SIERRA CLUB'S
SUBMITTAL OF SYNAPSE
ENERGY ECONOMIC'S
REPORT REBUTTING THE
NAVIGANT PRESENTATION
ON THE FUTURE OF THE
NAVAJO GENERATION
STATION

Docket No. E-00000C-17-0039

Chasing the Elusive Benefits of Navajo Generating Station

A Review of Peabody & Navigant's Navajo Economic Assessment

Figure 1. Navigant/Peabody Energy Economic Analysis of Navajo Power Station

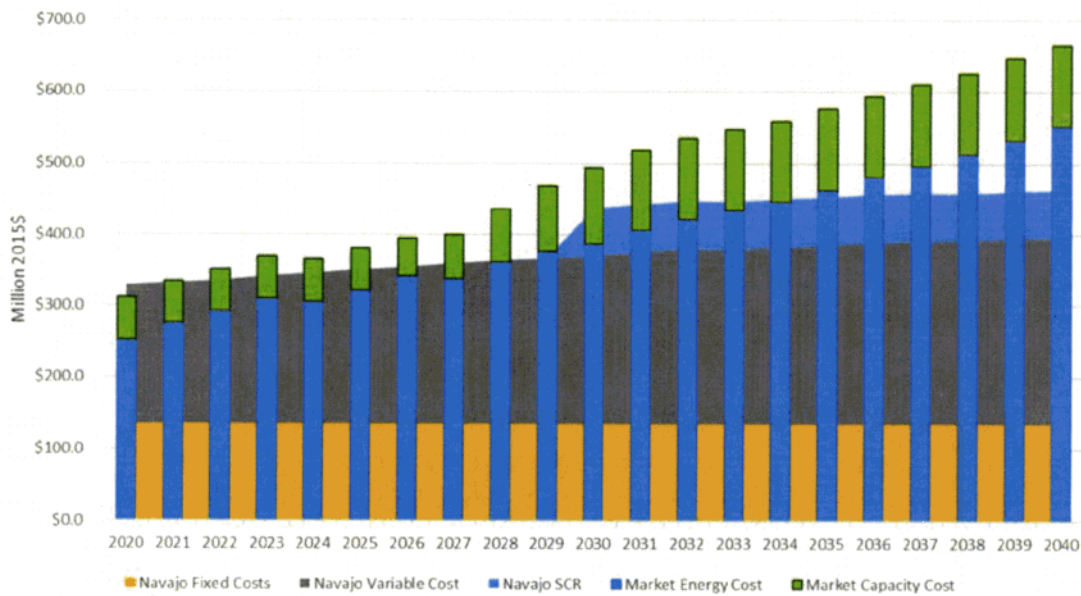
There are several immediately notable features of this analysis. First, even under Navigant’s assumed pricing, Navajo barely breaks even on an annual basis until market energy and capacity prices begin

rising in the late 2020s. Second, Navigant shows market energy costs (the blue bars) well in excess of Navajo's variable cost of production ("variable costs") even in 2020.

The first feature, the long span until a break-even, is important in evaluating the risk of maintaining the plant. Even under Navigant's generous assumptions, Navajo doesn't start paying back substantially until the late 2020s, meaning that any owner would have to be willing to absorb the risk of stagnant energy prices or rising coal prices for another decade. Few new owners would be willing to take on such a risk profile, effectively betting ratepayer dollars on a market recovery.

The second feature, the high market energy costs in early years relative to the variable cost of production at Navajo, implies that Navajo should be making large energy margins today and through 2020, a fact that is belied by the falling capacity factor of the plant, and the losses being incurred by Navajo's owners today. In a recent presentation, Central Arizona Project (CAP) estimated that it "would have saved \$38.5 million in 2016 by buying energy on the market instead of from NGS."²

Figure 2. Coal fuel prices as delivered to Navajo Power Station 2008-2016,³ as assumed by Navigant,⁴ and extrapolated. 2015\$/MMBtu.

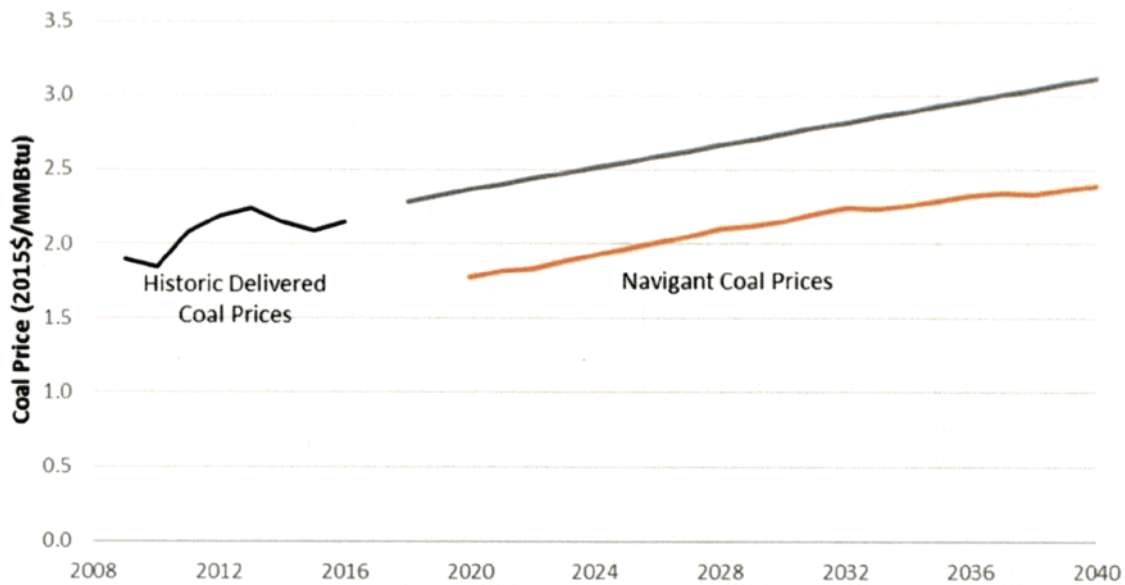
Navigant's presentation has a footnote that reads "Assumes Peabody proposed coal prices, with annual \$2/ton carry on coal prices 2026 and later." A breakdown of Navigant's analysis shows that the consultancy ended up using coal prices substantially lower than historic delivered prices, only reaching Kayenta's actual delivered prices from 2016 in the year 2029.

A reasonable extrapolation of coal prices paid by Navajo to the Kayenta Mine (2008-2016) reveals a constant underpricing by Navigant of about \$0.75/MMBtu. While this pricing difference may appear relatively small, the impact on the overall economics of Navajo is substantial. Replacing Navigant’s coal prices with the extrapolated fuel price increases the relative cost of Navajo by \$65-\$80 million per year, or about **\$620 million** (NPV 2020-2040),⁵ completely erasing Navigant’s assumed benefit for Navajo over the full analysis period.

Figure 3. Estimated production cost at NGS 2008-2016 from FERC Form 1 data,¹¹ as assumed by Navigant, and based on EIA and FERC forward-looking.¹² 2015\$/MWh.

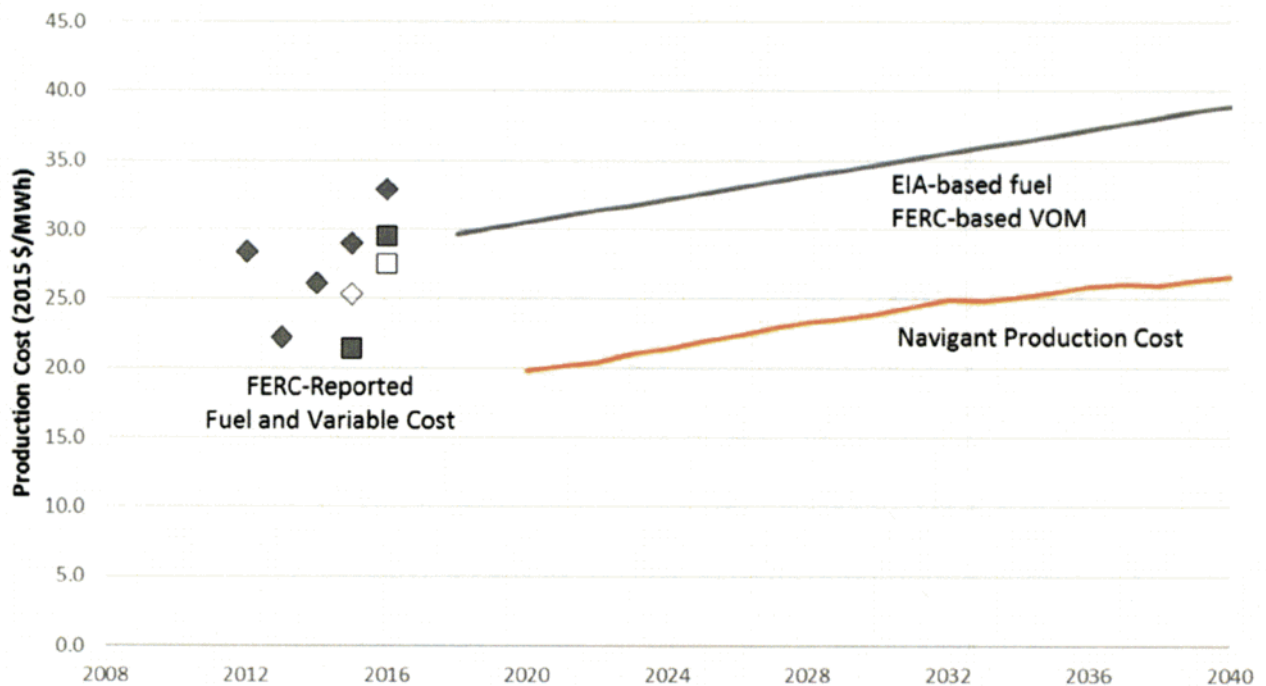
A review of federal filings from Navajo co-owners Arizona Public Service Company,⁷ Tucson Electric Power,⁸ Nevada Energy Company,⁹ and Salt River Project,¹⁰ suggests that Navajo pays about \$3.80/MWh in variable O&M costs, apparently also not captured by Navigant. Figure 3, below, shows historic costs of fuel and variable O&M as reported to the Federal Energy Regulatory Commission (FERC) from Navajo participants against Navigant's total production costs. It shows that Navigant's assumed production costs in 2020 are lower than any entity reported in any year 2008-2016, and stay well below the average cost of Navajo in every year of the analysis.

We assess that between fuel and variable O&M, Navigant excluded nearly \$950 million in costs at Navajo (NPV 2020-2040). But these exclusions are only the start of the flaws in this study.

Figure 4. Market Energy prices in Navigant Study, forward-market prices from SNL Energy, and PacifiCorp 2017 IRP (April 2017).¹⁴

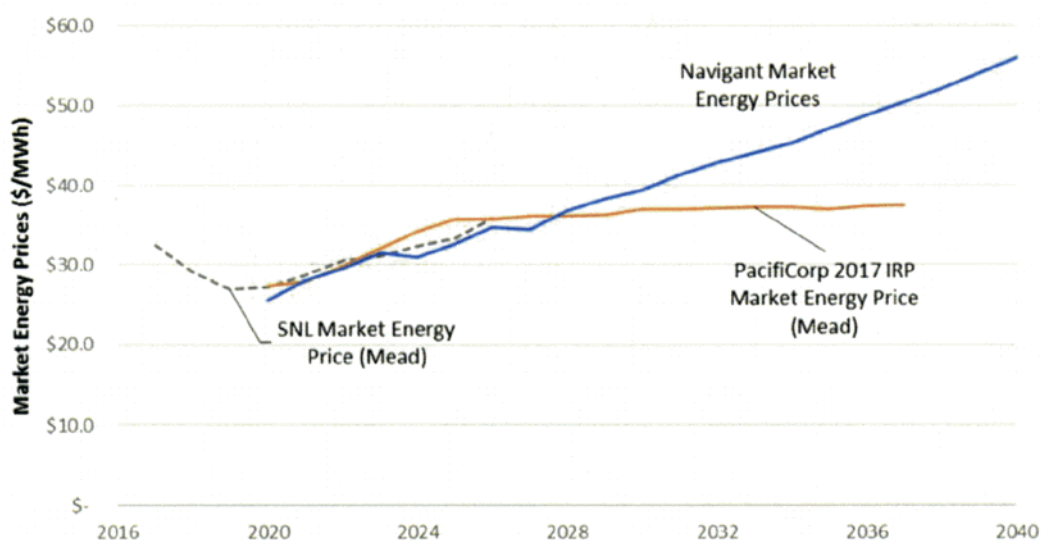
Comparing the PacifiCorp long-term “all hours” market price forecast¹⁵ against Navigant’s assumption indicates that Navigant’s extrapolated forecast is extremely aggressive in out years, explaining the substantial increase in market energy costs in the Navigant analysis. Comparing the market price

differential between these two forecasts suggests that market energy price inflation results in a **\$244 million** (NPV 2020-2040) excessive benefit in the Navigant study.

Figure 5. Navigant capacity market prices in Navajo study, 2015\$/MW-day.

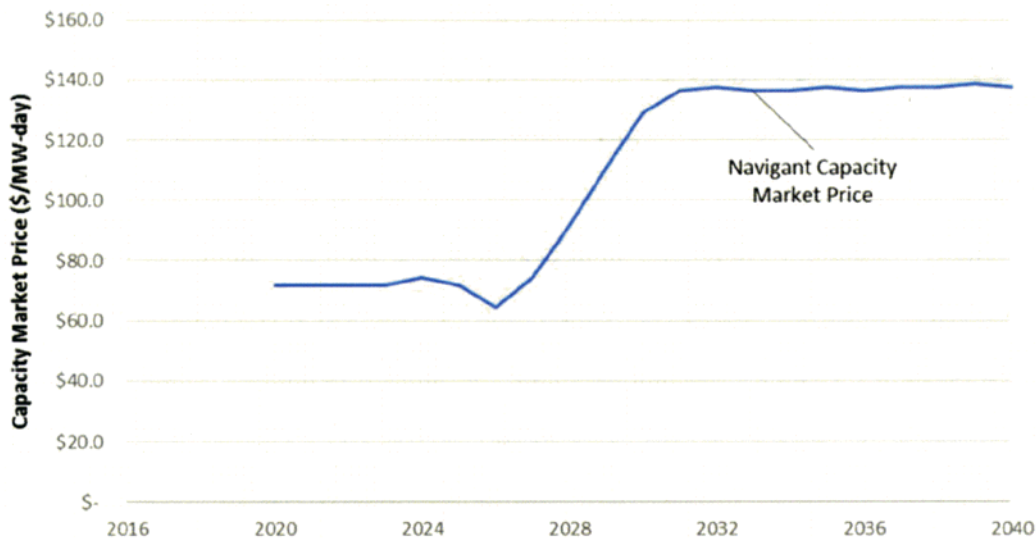
Navigant, however, assumed that there is a substantial regional need for capacity today, and market participants are willing to pay \$70/MW-day in 2020, or 46 times this year's actual market prices in the Midwest (MISO) region, which just cleared at \$1.5/MW-day.¹⁷ In fact, Navigant assumed that there is such an appetite for capacity that other utilities would be willing to pay nearly the full net cost of new entry (CONE) starting in 2030 (see Figure 5, below).

Navigant’s assumption about the appetite for capacity in the Southwest, and its inflated value to customers is an assumed benefit of **\$755 million** (NPV 2020-2040), a benefit unlikely to be realized by any party.
